2021/4691/P - Flat 2, 102 Haverstock Hill

Delegated Report			Analysis sheet		Expiry Da	ate: 12/01/2	2022	
(Members Briefing)			N/A		Consultation Expiry Date	14/17/	2021	
Officer				Application No	umber(s)			
Fast Track Team				2021/4691/P	2021/4691/P			
Application Address				Drawing Numl	Drawing Numbers			
Flat 2 102 Haverstock Hill London NW3 2BD				Refer to draft deci	Refer to draft decision notice			
PO 3/4	O 3/4 Area Team Signatu		C&UD	Authorised Of	Authorised Officer Signature			
Proposal(s)								
Replacement of existing window and door with new crittall double glazed window and door and new external flooring paving on the rear upper ground floor. Recommendation(s): Grant Conditional Permission						ng		
Application Type:		Full Planning Permission						
Conditions or Reasons for Refusal:		Refer to Draft Decision Notice						
Informatives:								
Consultations								
Adjoining Occu	piers:	No. notified	00	No. of responses	01 No	o. of objections	01

1.1 Planning permission is sought for the replacement of existing window and door with new crittall double glazed window and door and new external flooring paving on the rear upper ground floor.

2. Aerial photograph from the rear (photo from Bing)

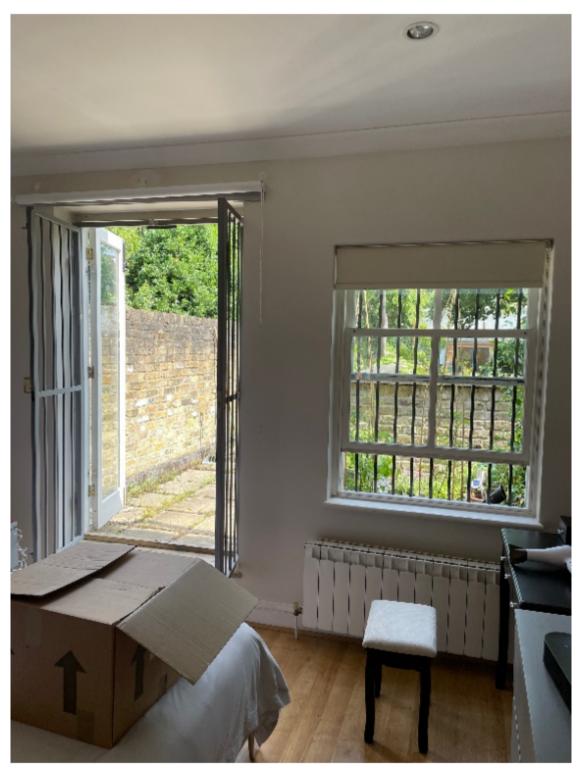
- 3.3 Additionally, while it would be preferable to replace the existing window and door with vertical panes to match the windows on the upper floors, in the context of the host building, the extension is a more recent addition to the house built in the 1990s and not part of the original architecture. There are also existing metal bars to the current window and door that will be removed in order to accommodate the new proposal and for all those reasons, it would be acceptable in principle.

- 3.4 It should be noted that the replacement of the existing window and door would not be visible in the street scene. They are not visible from the public domain as the proposed work is located at the rear of the property. They will only be visible from the private rear gardens. Furthermore, the rear end of the garden faces the back of a school building with no fenestration. The visual impact would therefore be negligible and would not cause harm or sufficient impact to warrant refusal.
